**IHL# 201-259**  
**Upgrades & Renovation Poultry Processing Facility & Incinerator Shed**  
**Alcorn State University**  
**Lorman Campus**  
**Project Number: 2021-002**

**Addendum No. 2**

09October2023

Drawing Title  
PREFABRICATED GARAGE  
FOUNDATION DETAILS

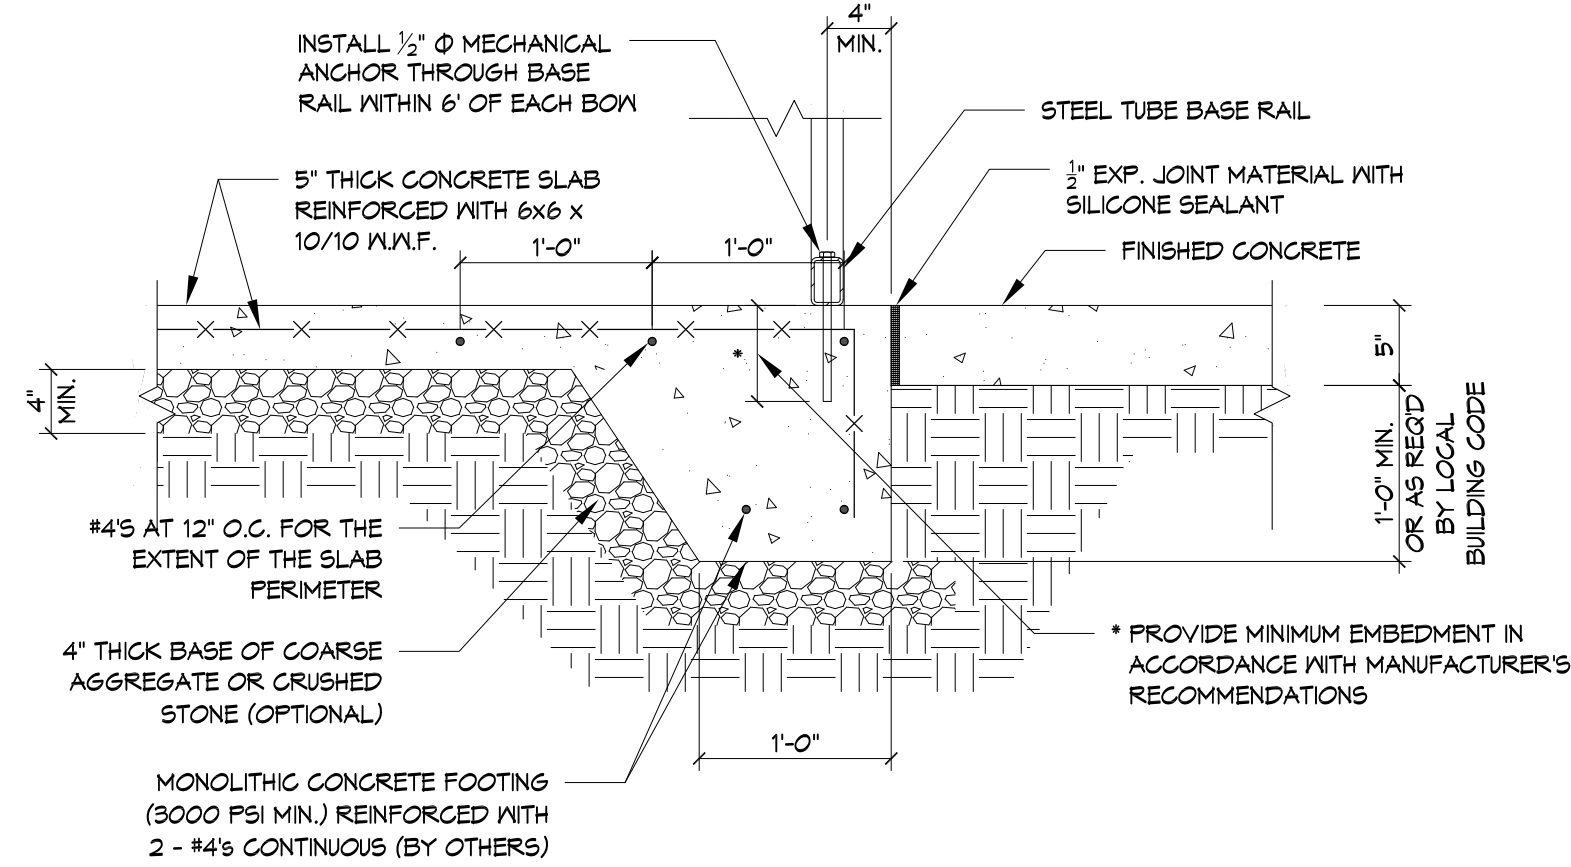
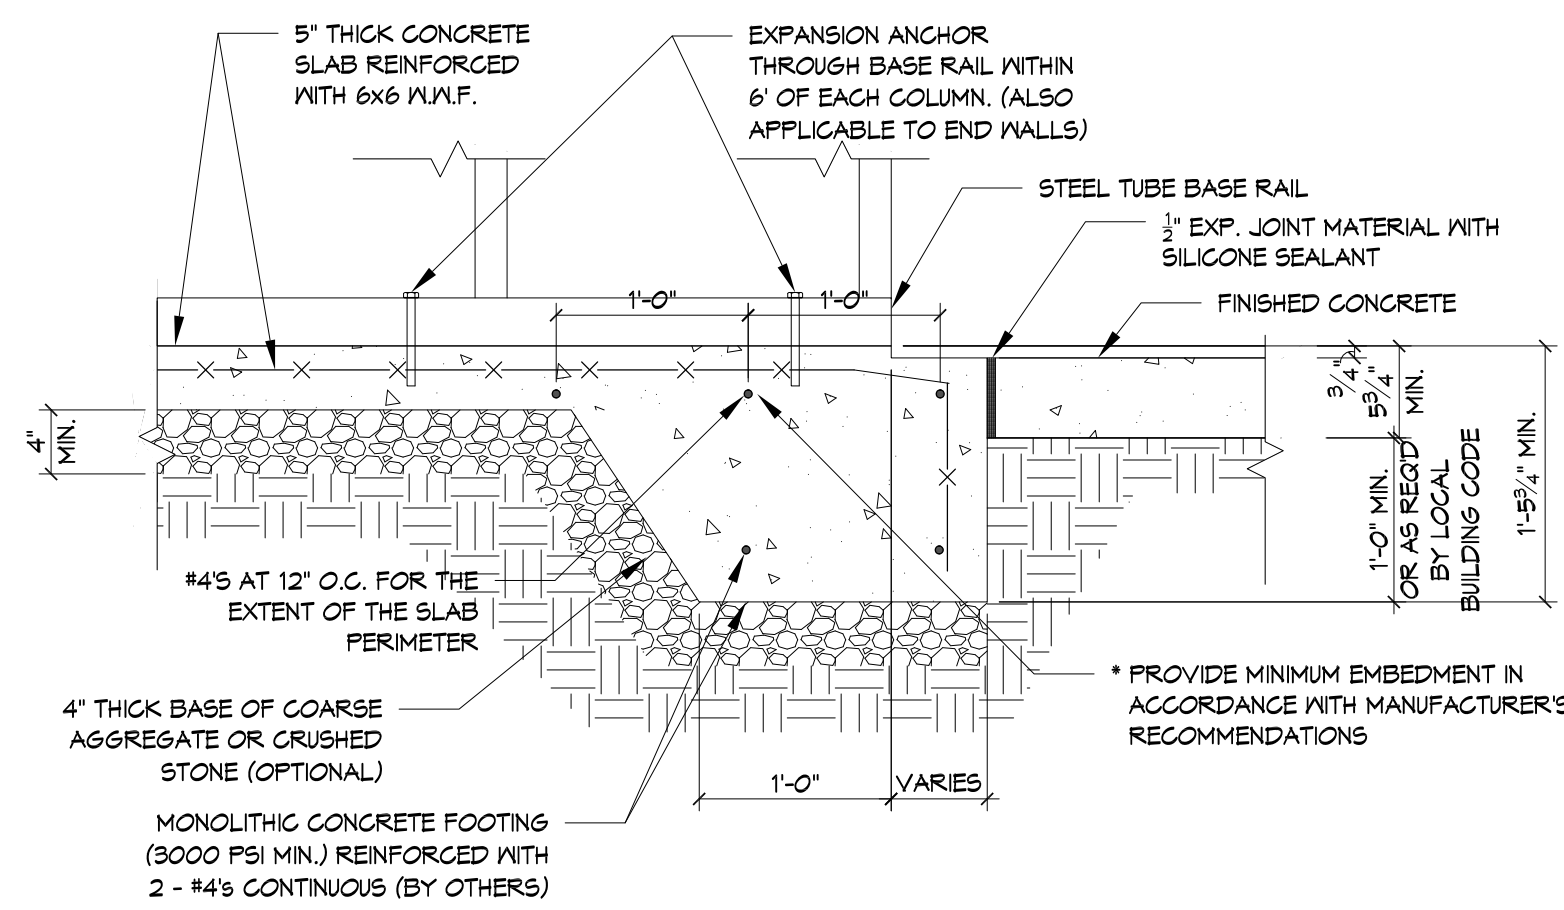
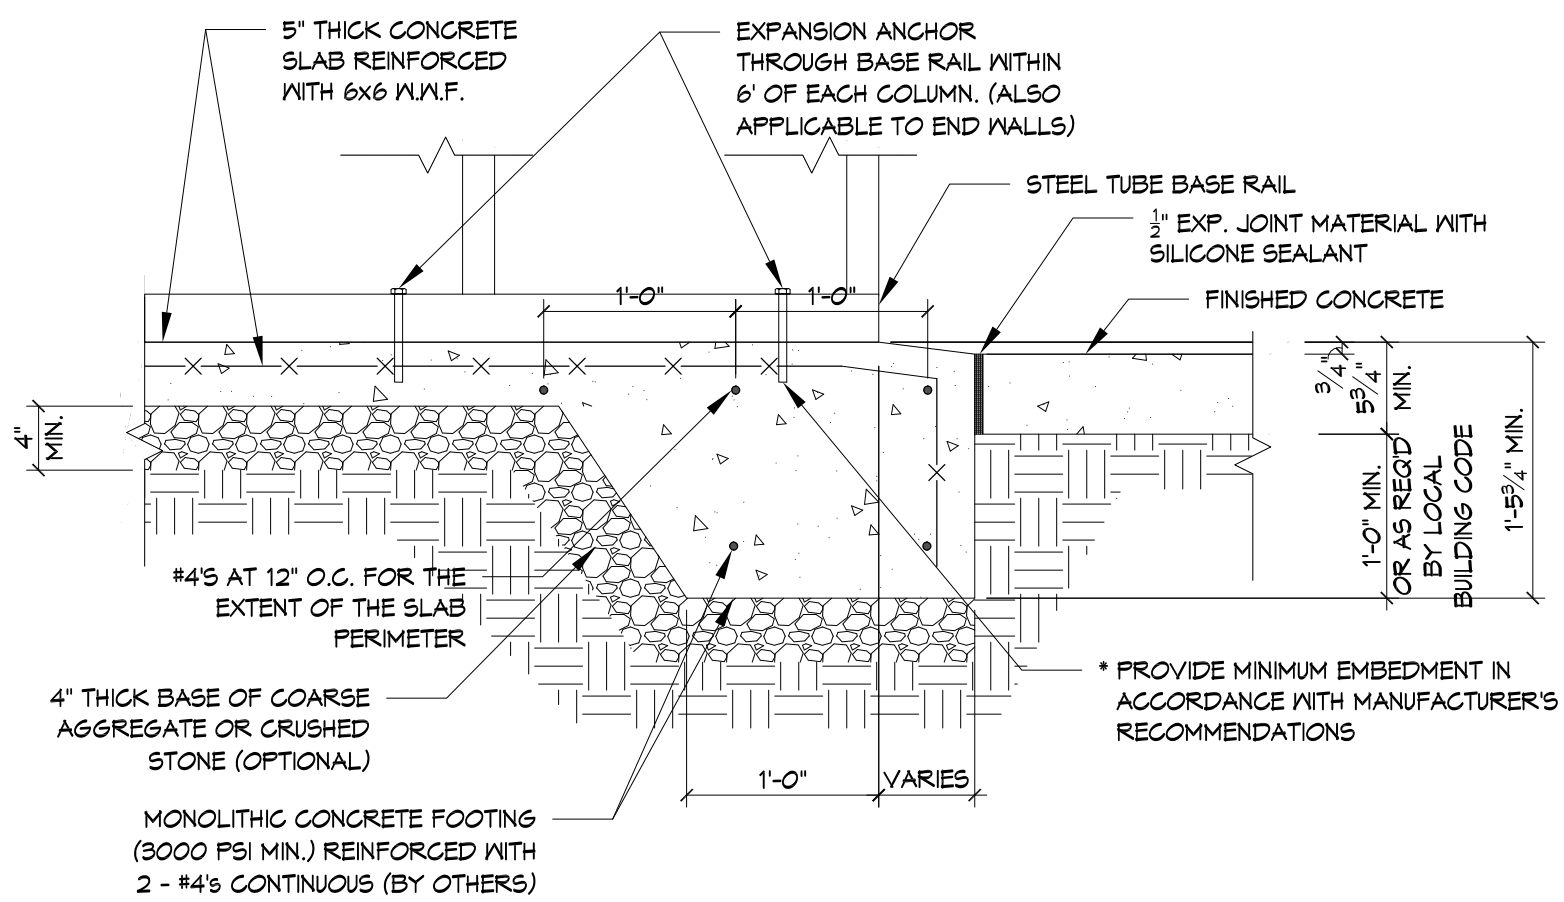
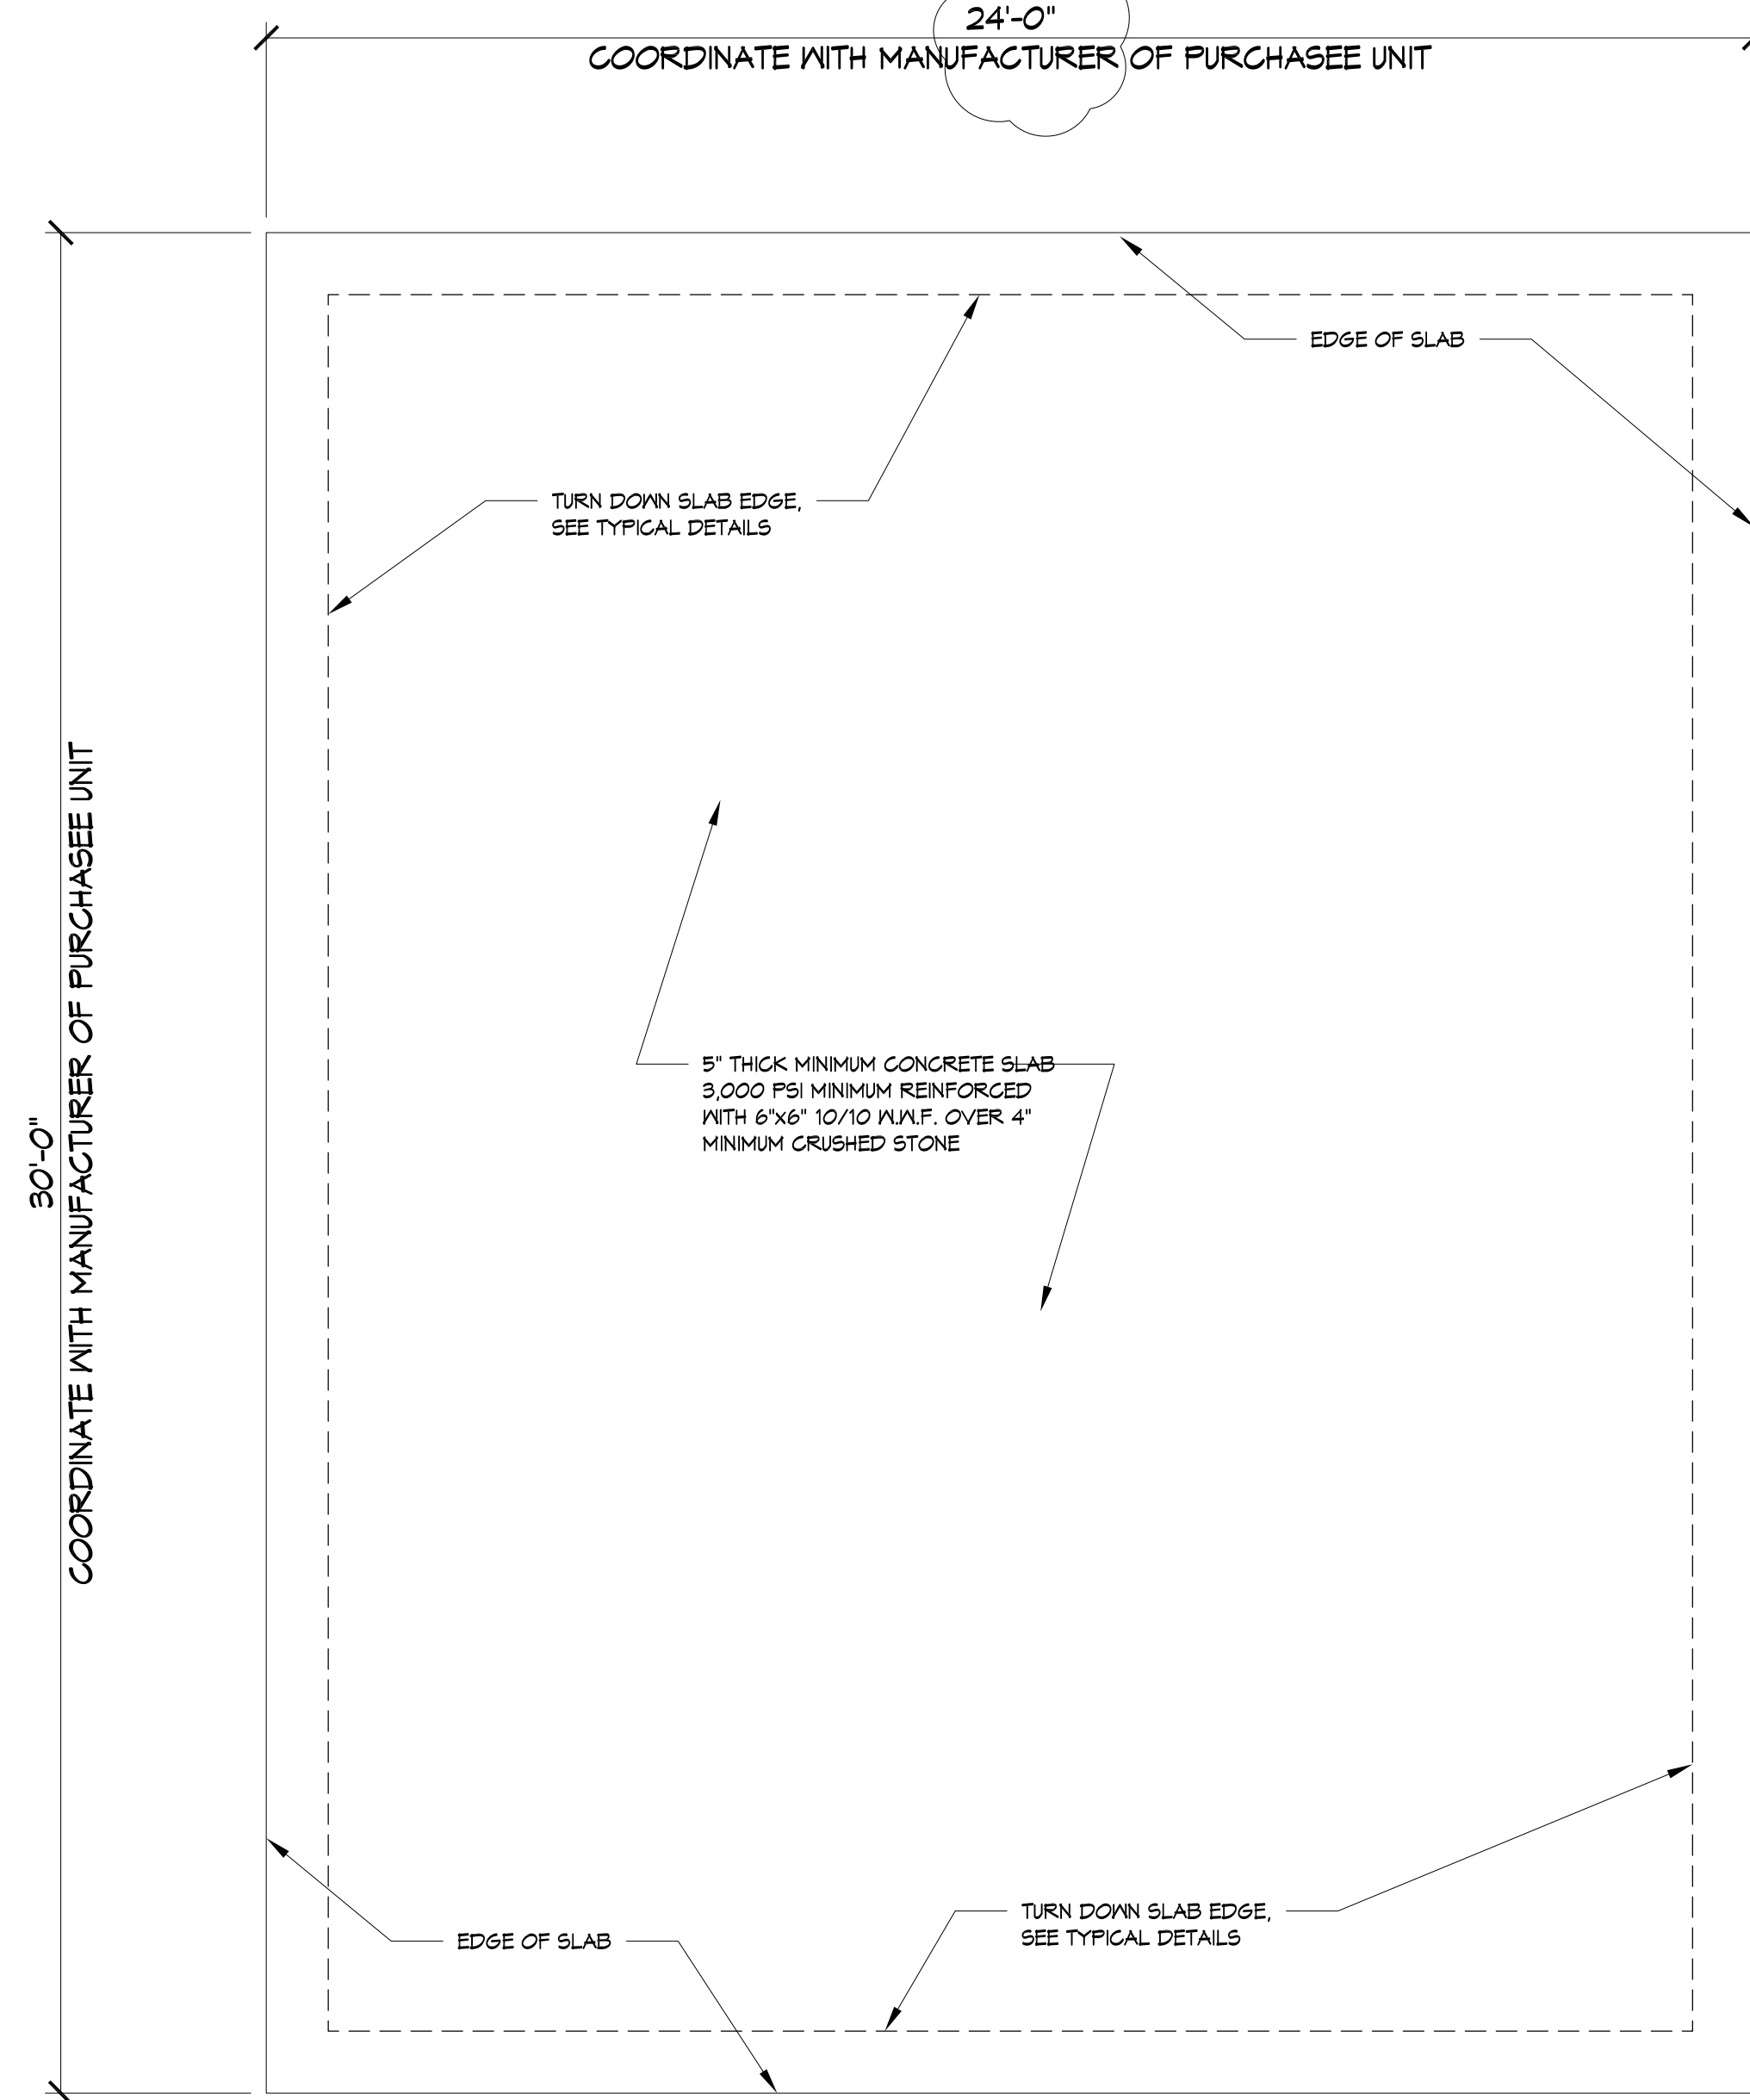
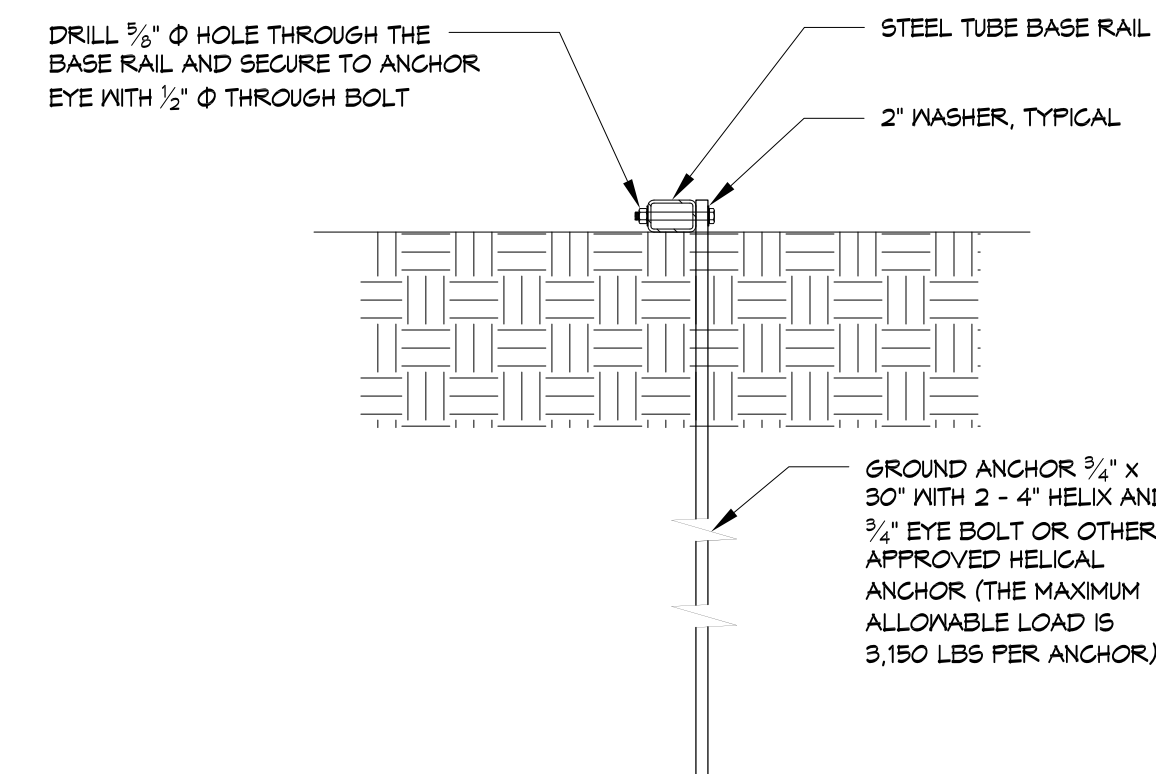
- Item No. 1      Modify attached drawing - Sheet A-106. Add descriptive information which describes the attributes and characteristics for the new prefabricated garage.

- A) Size: 24'-0" x 30'-0" nominal  
B) Concrete Pad: 24'-0" x 30'-0"  
C) Regular Roof Metal Garage; Pitch - 3 in 12  
D) Roof Color: Pewter Gray  
E) Trim Color: White  
F) Side & End Color: Pewter Gray  
G) Garage Door Color: White  
H) Galvanized Screws: Silver  
I) Certified Loads: 150 mph & 35 psf  
J) Tubing: 12 GA  
K) Sheetting: 26 GA - horizontal installation  
L) Leg Height: 11'-0" on the 30'-0" Long Sides  
M) Ends: 24'-0" Wide - Close Both 11' Ends  
N) Insulation Type: Double Bubble Insulation on 11' Leg Height - 24x30  
O) Fully Insulate Roof and Sides  
P) 2 Garage Doors 10'-0" x 8'-0": Two 10'-0" Wide x 8'-0" Tall Garage Doors  
Q) Walk in Door: One Single Walk in Door 36" Wide x 80" Tall, on Side 1'-0" From Front End  
R) PROVIDE MINIMUM ONE YEAR WARRANTY FOR WORKMANSHIP
